Subject: Addendum No. 5
ITB 22-043 – HVAC Replacement – Main Library
New Estimate, Alternate Bid, Updated Drawings, Pre-Bid Meeting, New Deadline

COLUMBUS METROPOLITAN LIBRARY
96 South Grant Avenue
Columbus, OH 43215
AIR HANDLING UNIT REPLACEMENT

AIR HANDLING UNIT REPLACEMENT

H204A – HVAC ROOF NEW WORK PLAN – AREA A

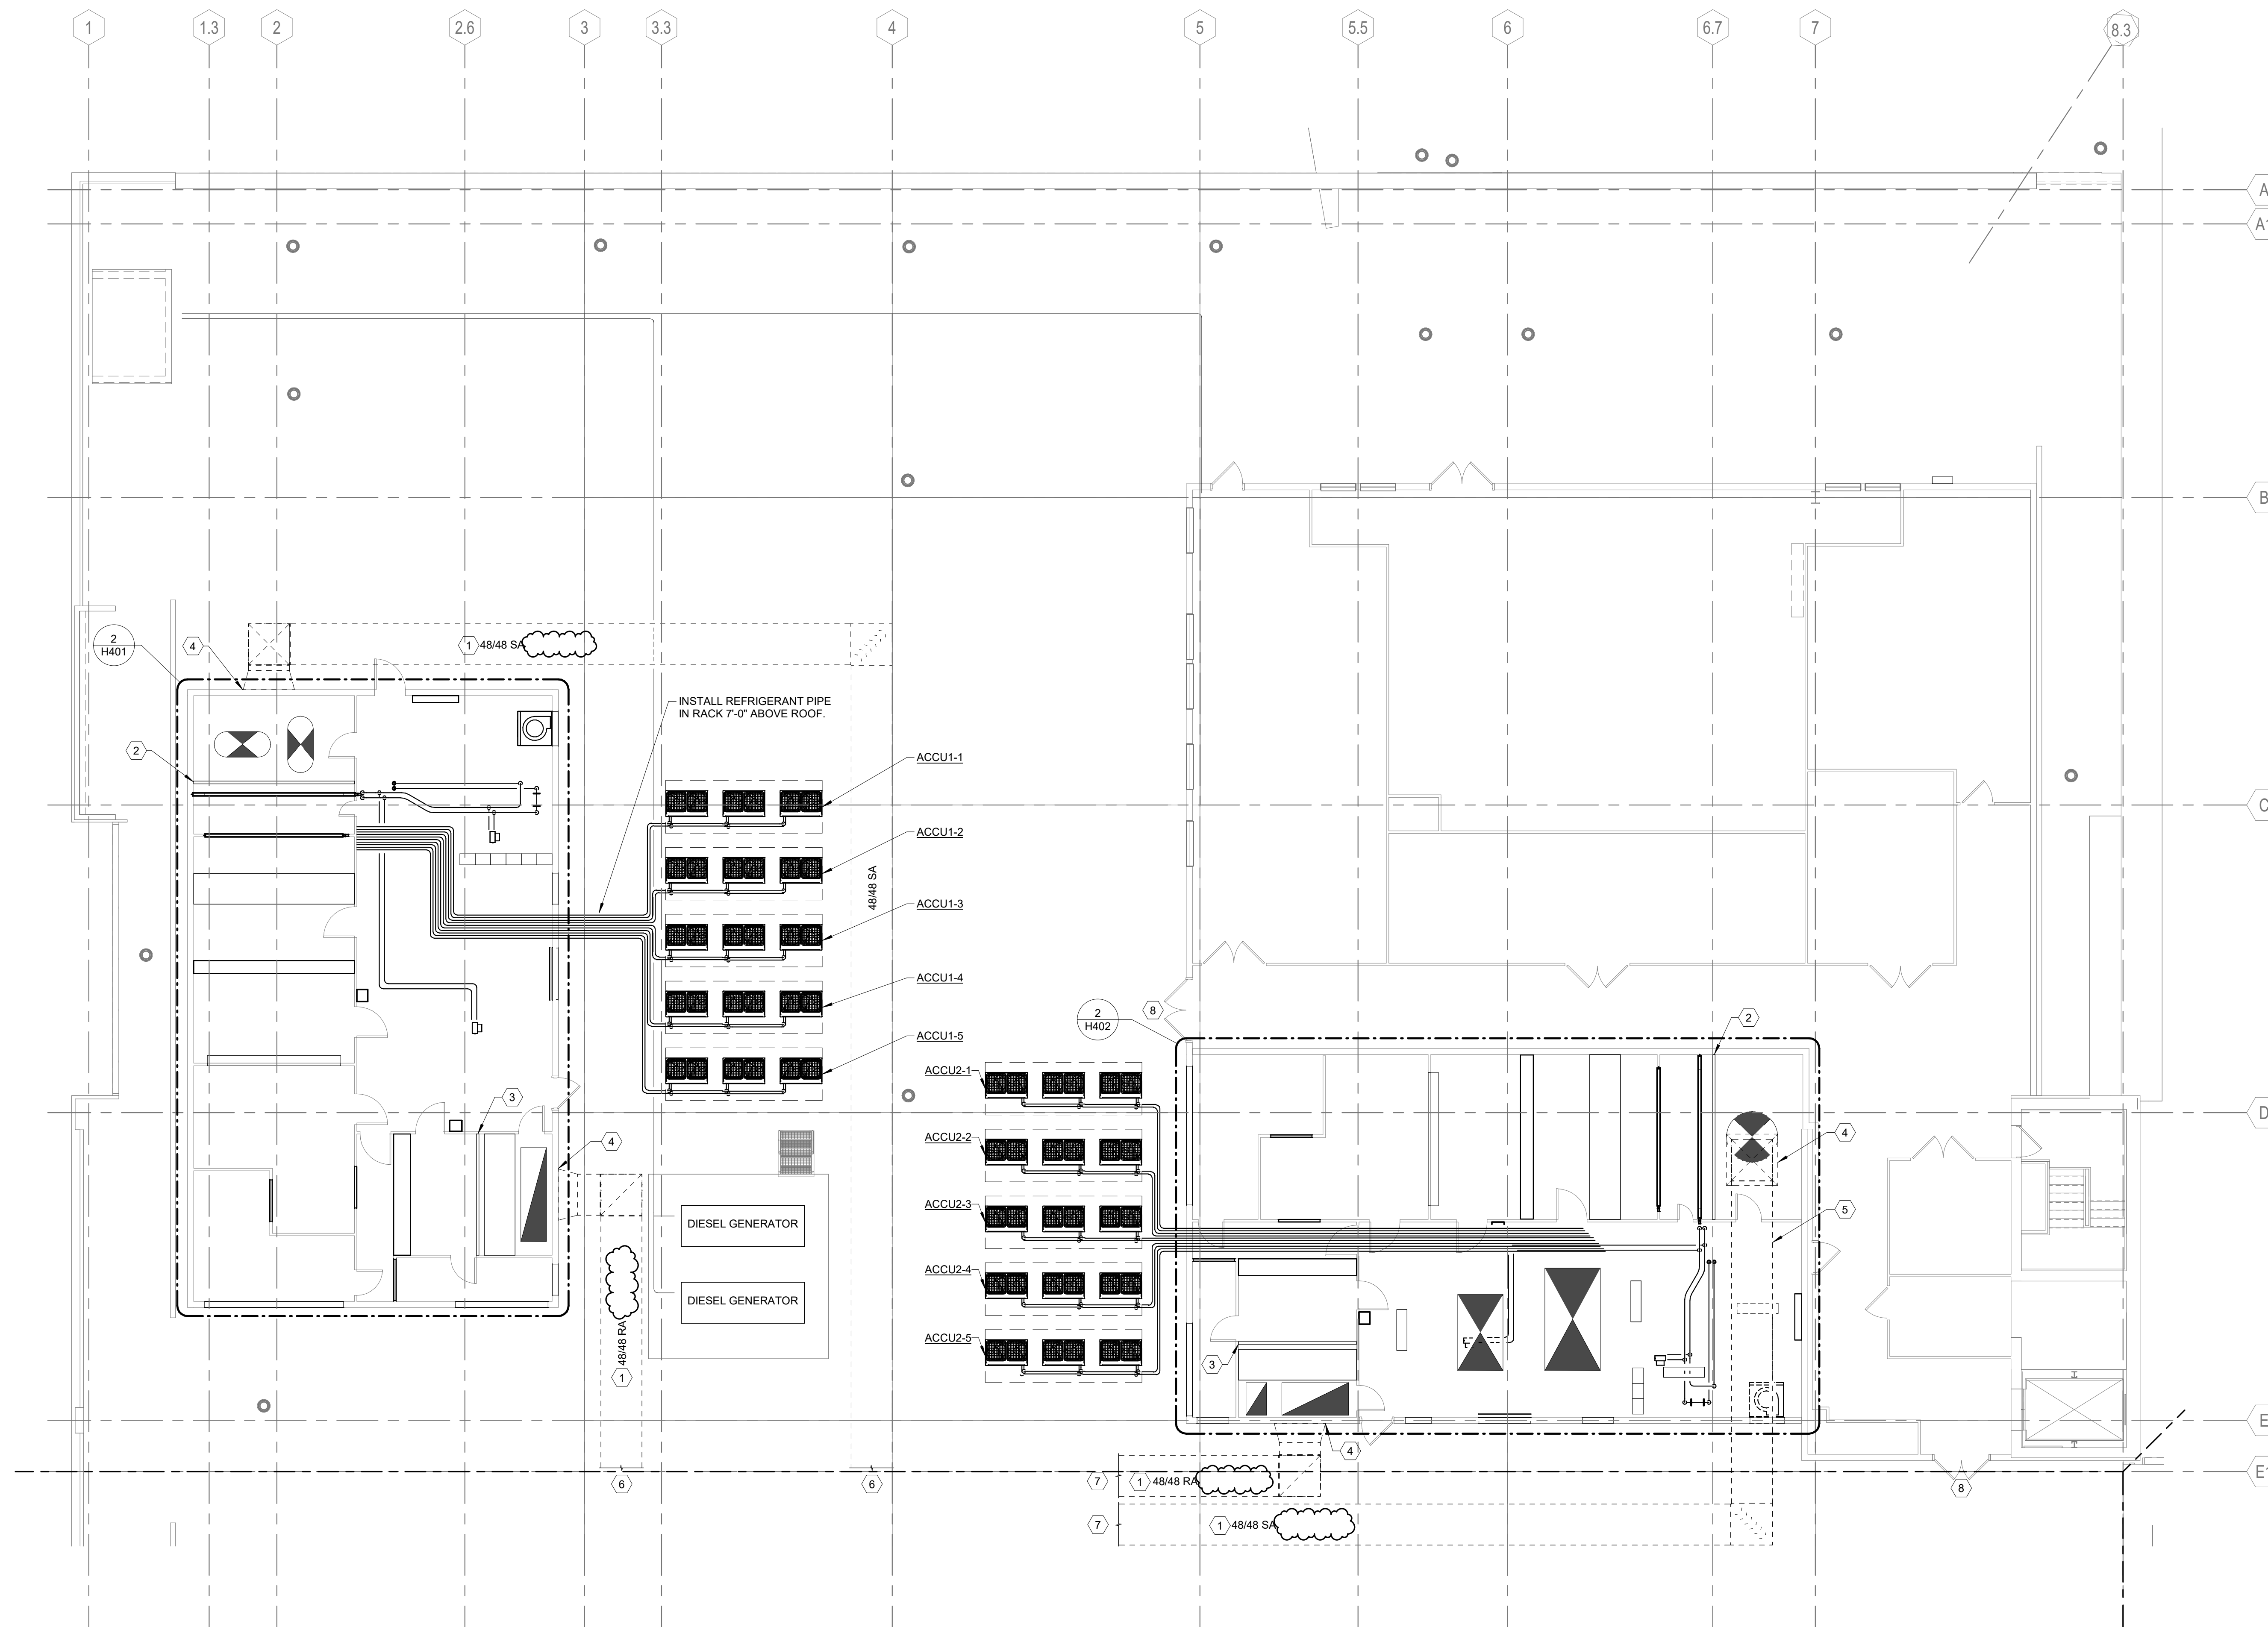
Revise general note 2 requiring contractor be responsible for installing temporary ductwork to withstand high winds. Revise coded note 1 removing the requirement to support temporary ductwork overhead.

H204B – HVAC ROOF NEW WORK PLAN – AREA B

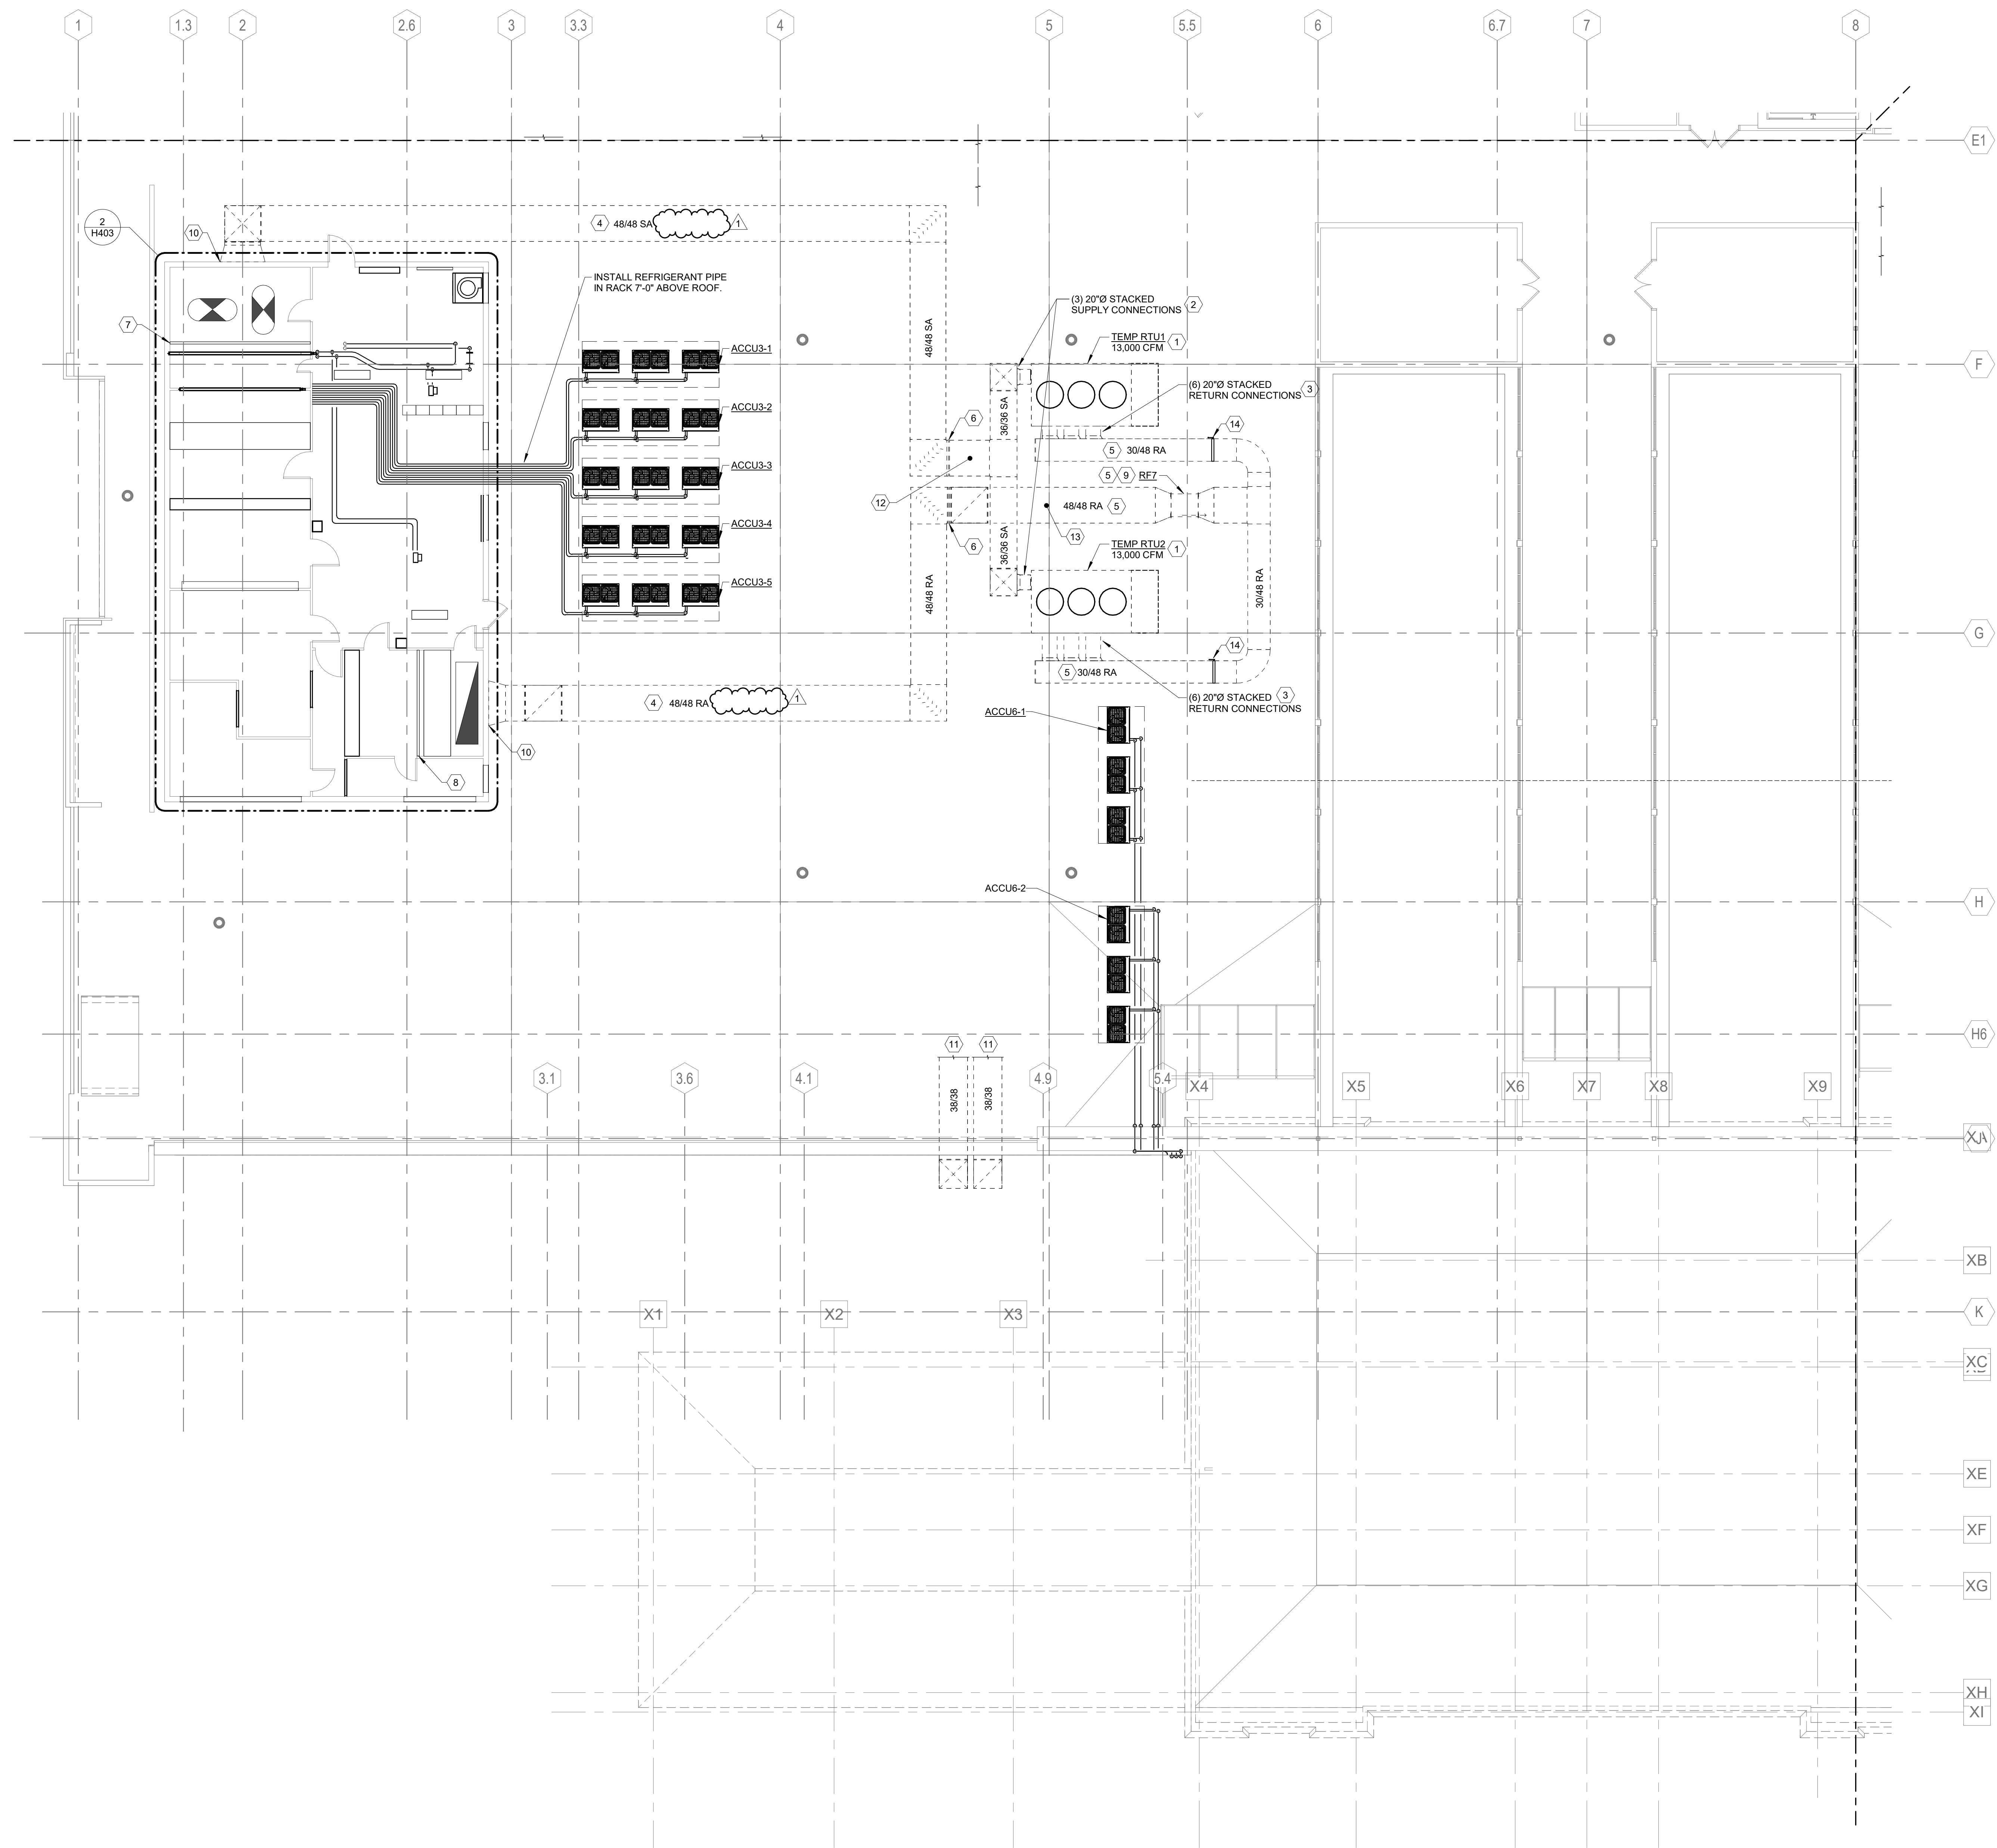
Revise general note 2 requiring contractor be responsible for installing temporary ductwork to withstand high winds. Revise temporary RTU requirements coded note 1. Revise coded note 3 removing the requirement to support temporary ductwork overhead.
